| PROJECT<br>RYLANDS BUILDING,<br>MANCHESTER |   |                      |   |                  |          |  |
| TITLE<br>COMPARISON PLAN SEVENTH FLOOR     |   |                      |   |                  |          |  |
| JOB No<br>1526                             |   | DWG No<br>AL[05]4220 |   |                  | REV<br>* |  |
| ISSUE FOR<br>PLANNING DOCUMENT             |   |                      |   |                  |          |  |

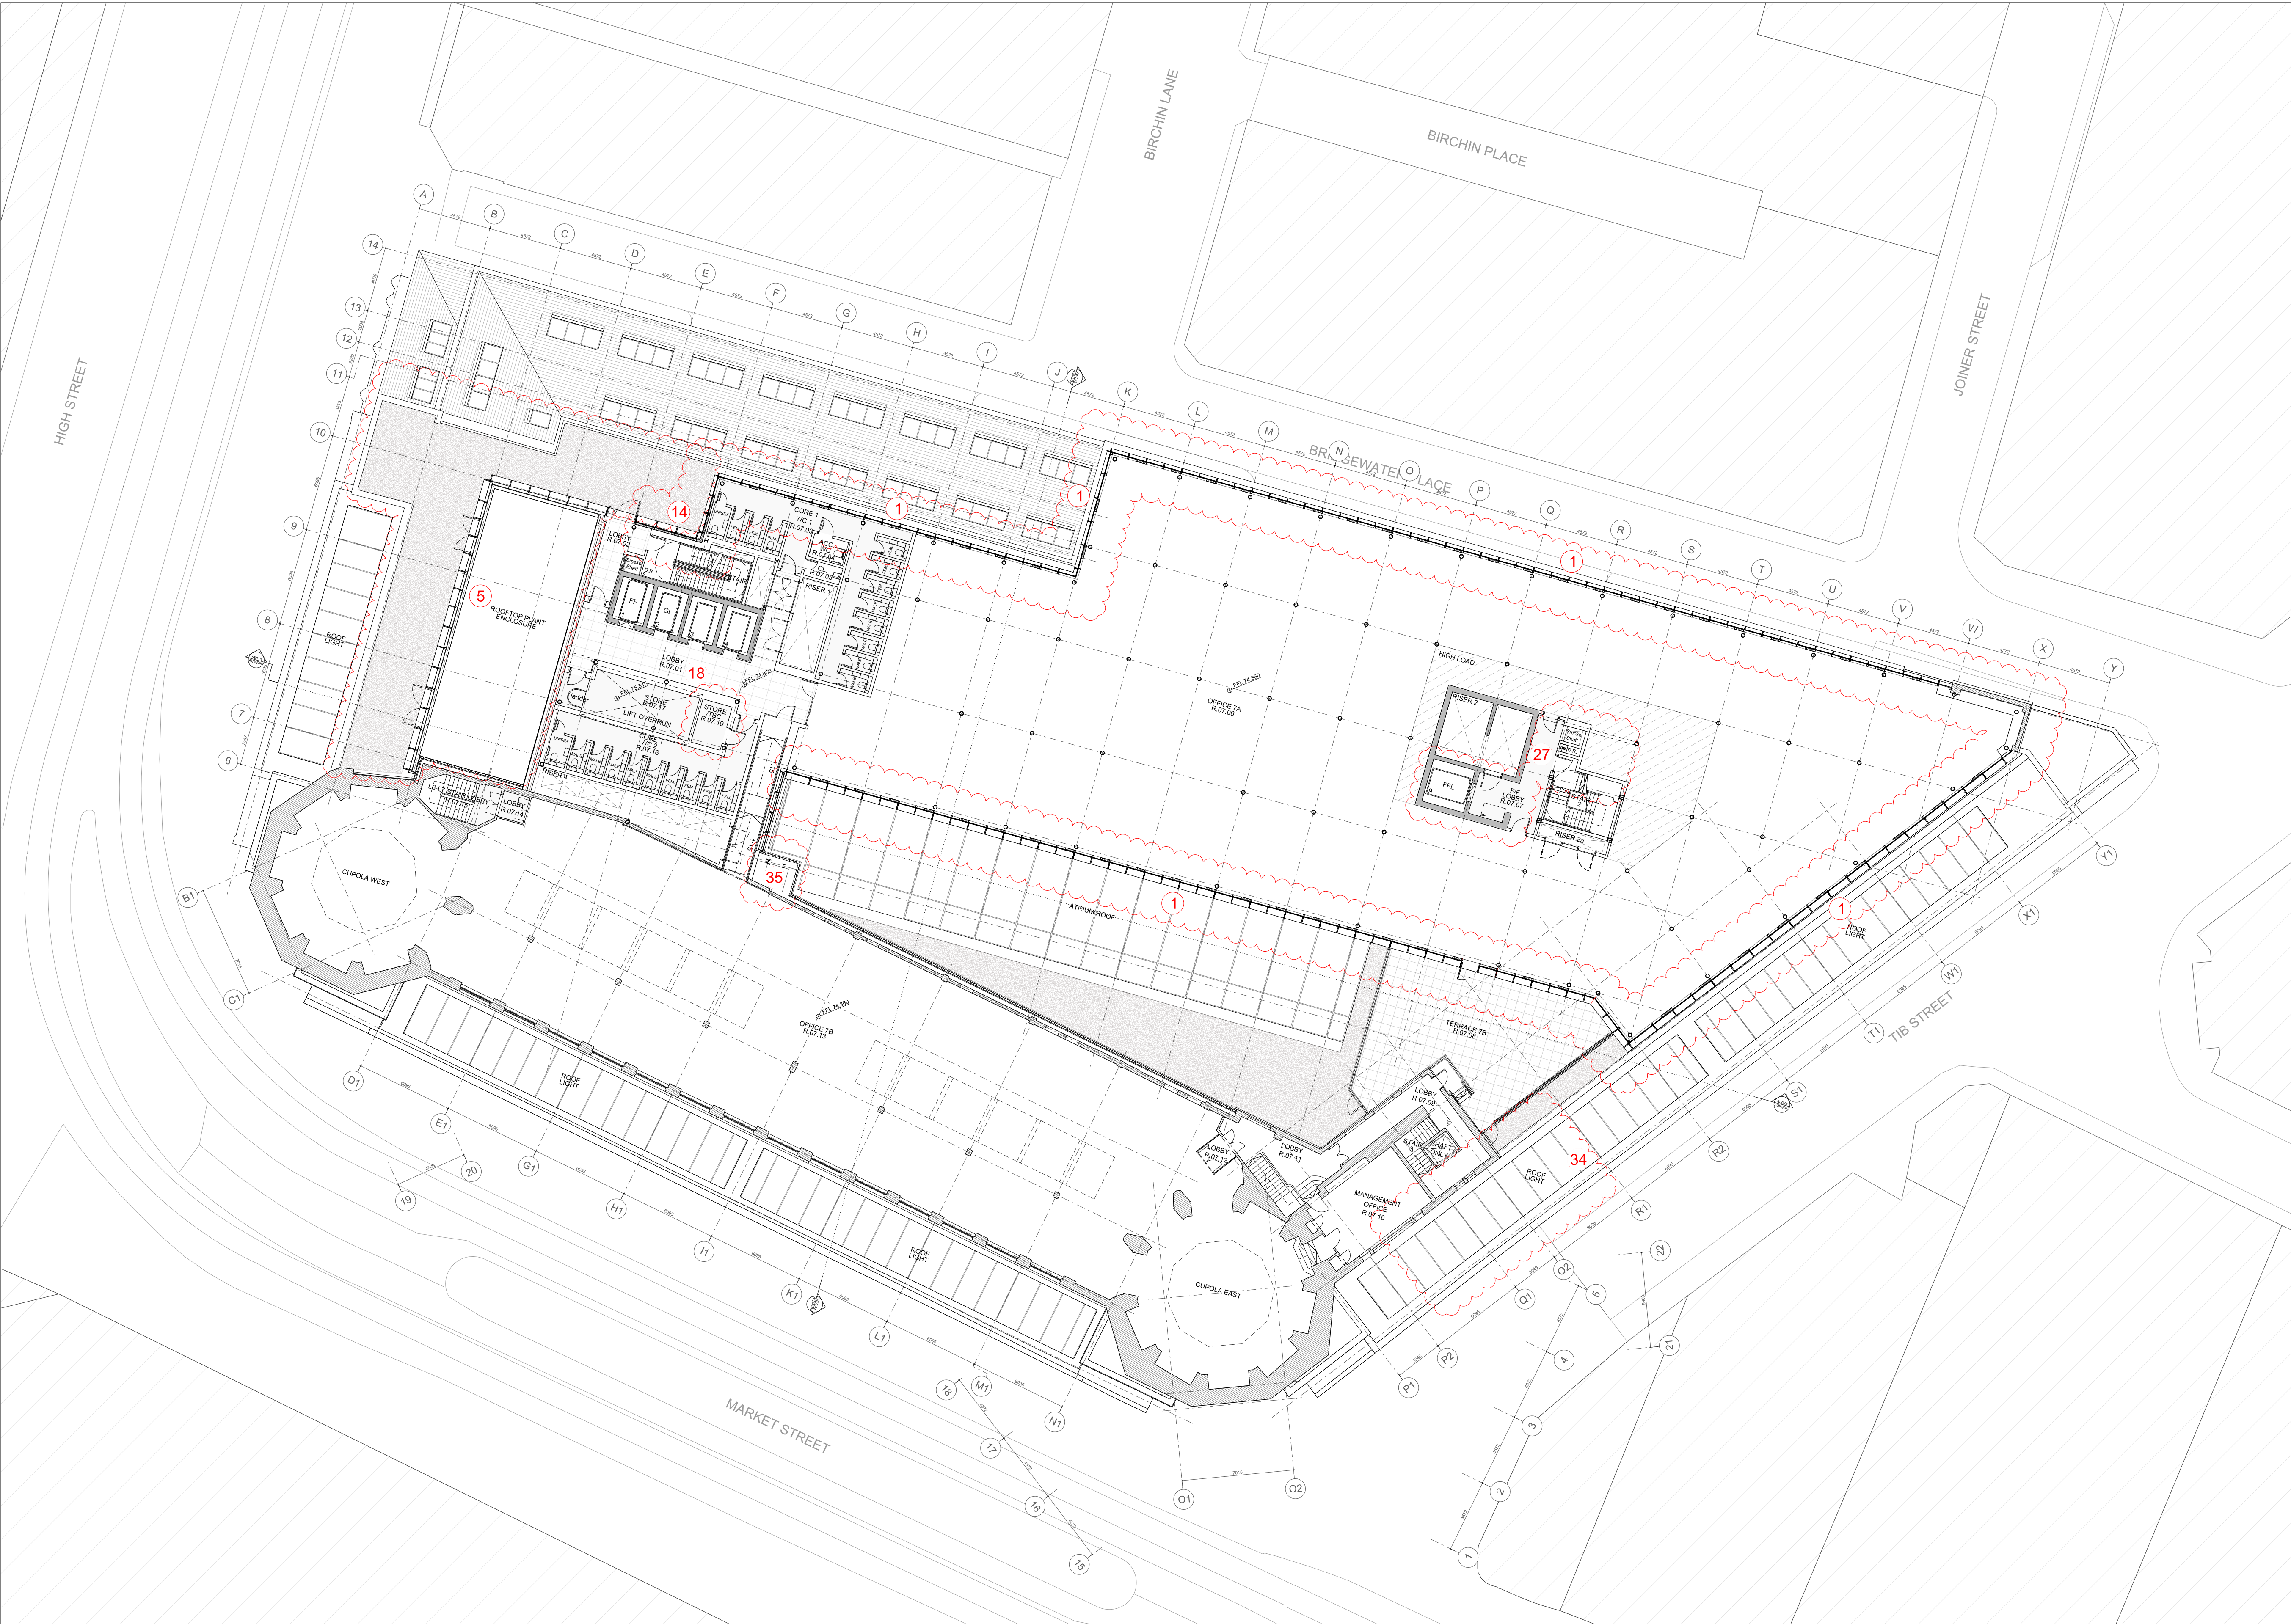
| PRINCIPLE DESIGN DEVELOPMENTS KEY                                                                                                           |                                                                                                                                                                                                                 |                                                                                                                                                                   |                                                                                                                  |
|---------------------------------------------------------------------------------------------------------------------------------------------|-----------------------------------------------------------------------------------------------------------------------------------------------------------------------------------------------------------------|-------------------------------------------------------------------------------------------------------------------------------------------------------------------|------------------------------------------------------------------------------------------------------------------|
| 1 Double-mullions & Parallel Opening Vents omitted from extension elevations                                                                | 5 Terrace 7A omitted. New back-painted glass screen to accommodate new VRF MEP servicing strategy at existing roof level. PPC vent louvers to lid, & to base of West elev, concealed behind main stone parapet. | 8 Overall height remains unchanged from the consented scheme.                                                                                                     | 12 New Market Hall entrance door arrangements                                                                    |
| 2 Saw-tooth roof profiles reduced in number & length. Sawtooth structures to carry PV panels only, thermal envelope now at roof slab level. | 6 New Market Hall Unit & revised Office Foyer at Ground Floor Level                                                                                                                                             | 9 Roof-plant enclosure reduced in width & lengthened to GL. H to accom. VRF MEP strategy. PPC vent louvers to base of South & North elevs concealed by sawtooths. | 13 Updated Cycle-store entrance and exit arrangements                                                            |
| 3 Core 2 lift overrun height lowered within Roof Plant enclosure due to VRF MEP strategy.                                                   | 7 Lower floors replanned (see notes on General Arrangement plan drawings).                                                                                                                                      | 10 Double-mullions omitted from Shop-front glazing                                                                                                                | 14 Back-painted glass in glazed facade system to match main facade system - Profiled metal cladding omitted.     |
| 4 Glazing sections to Atrium simplified.                                                                                                    |                                                                                                                                                                                                                 | 11 New fire exits required to Shopfronts for Market Hall use                                                                                                      | 15 Lift overrun wall widened to conceal adjacent plant.                                                          |
|                                                                                                                                             |                                                                                                                                                                                                                 |                                                                                                                                                                   | 16 Protected Lobby update.                                                                                       |
|                                                                                                                                             |                                                                                                                                                                                                                 |                                                                                                                                                                   | 17 Store area adjusted.                                                                                          |
|                                                                                                                                             |                                                                                                                                                                                                                 |                                                                                                                                                                   | 18 Lift 8 omitted. Void/Store/tbc                                                                                |
|                                                                                                                                             |                                                                                                                                                                                                                 |                                                                                                                                                                   | 19 Drop shaft relocated.                                                                                         |
|                                                                                                                                             |                                                                                                                                                                                                                 |                                                                                                                                                                   | 20 Facilities Management & General Back of House areas updated to accommodate Market Hall.                       |
|                                                                                                                                             |                                                                                                                                                                                                                 |                                                                                                                                                                   | 21 Plant and bin store arrangement updated to accommodate Market Hall.                                           |
|                                                                                                                                             |                                                                                                                                                                                                                 |                                                                                                                                                                   | 22 Lobby arrangement to increase locker provision within changing                                                |
|                                                                                                                                             |                                                                                                                                                                                                                 |                                                                                                                                                                   | 23 Cycle lift & ramp omitted for new cycle-stair, reducing structural impact                                     |
|                                                                                                                                             |                                                                                                                                                                                                                 |                                                                                                                                                                   | 24 Continuity of EXTG Floor area (hatched) subject to investigation - possibly ground bearing slab at high level |
|                                                                                                                                             |                                                                                                                                                                                                                 |                                                                                                                                                                   | 25 Updated lobby & stair entrance preserving more of existing building fabric.                                   |
|                                                                                                                                             |                                                                                                                                                                                                                 |                                                                                                                                                                   | 26 Lobby arrangement to increase in area.                                                                        |
|                                                                                                                                             |                                                                                                                                                                                                                 |                                                                                                                                                                   | 27 Core 2 Lift functions & service levels rationalised for efficiency                                            |
|                                                                                                                                             |                                                                                                                                                                                                                 |                                                                                                                                                                   | 28 Ramp external to Stair 3 lobby                                                                                |
|                                                                                                                                             |                                                                                                                                                                                                                 |                                                                                                                                                                   | 29 Equipment Room provided.                                                                                      |
|                                                                                                                                             |                                                                                                                                                                                                                 |                                                                                                                                                                   | 30 Rooflights rationalised into singular rooflight                                                               |
|                                                                                                                                             |                                                                                                                                                                                                                 |                                                                                                                                                                   | 31 Cleaning facilities provision updated.                                                                        |
|                                                                                                                                             |                                                                                                                                                                                                                 |                                                                                                                                                                   | 32 WC added.                                                                                                     |
|                                                                                                                                             |                                                                                                                                                                                                                 |                                                                                                                                                                   | 33 Extg balconies refurbished for reuse.                                                                         |
|                                                                                                                                             |                                                                                                                                                                                                                 |                                                                                                                                                                   | 34 Winter Garden omitted.                                                                                        |
|                                                                                                                                             |                                                                                                                                                                                                                 |                                                                                                                                                                   | 35 External fabric amendment to accommodate existing structure.                                                  |
|                                                                                                                                             |                                                                                                                                                                                                                 |                                                                                                                                                                   | 36 Existing doorway retained, new door fitted to match new adjacent.                                             |
|                                                                                                                                             |                                                                                                                                                                                                                 |                                                                                                                                                                   | 37 Security bollards to Bridgewater Place entrance.                                                              |
|                                                                                                                                             |                                                                                                                                                                                                                 |                                                                                                                                                                   | 38 Bird & batbox proposed locations included.                                                                    |
|                                                                                                                                             |                                                                                                                                                                                                                 |                                                                                                                                                                   | 39 Partition line moved to increase commercial space.                                                            |
|                                                                                                                                             |                                                                                                                                                                                                                 |                                                                                                                                                                   | 40 Green roof to flat roof of L7 link.                                                                           |
|                                                                                                                                             |                                                                                                                                                                                                                 |                                                                                                                                                                   | 41 Ducting terminations in aesthetically coordinated metal sheathing.                                            |
|                                                                                                                                             |                                                                                                                                                                                                                 |                                                                                                                                                                   | 42 Renewables omitted @ L7 roof.                                                                                 |
|                                                                                                                                             |                                                                                                                                                                                                                 |                                                                                                                                                                   | 43 Horizontal plant-screen fins omitted.                                                                         |
|                                                                                                                                             |                                                                                                                                                                                                                 |                                                                                                                                                                   | 44 Overrun of Lift 10 removed.                                                                                   |
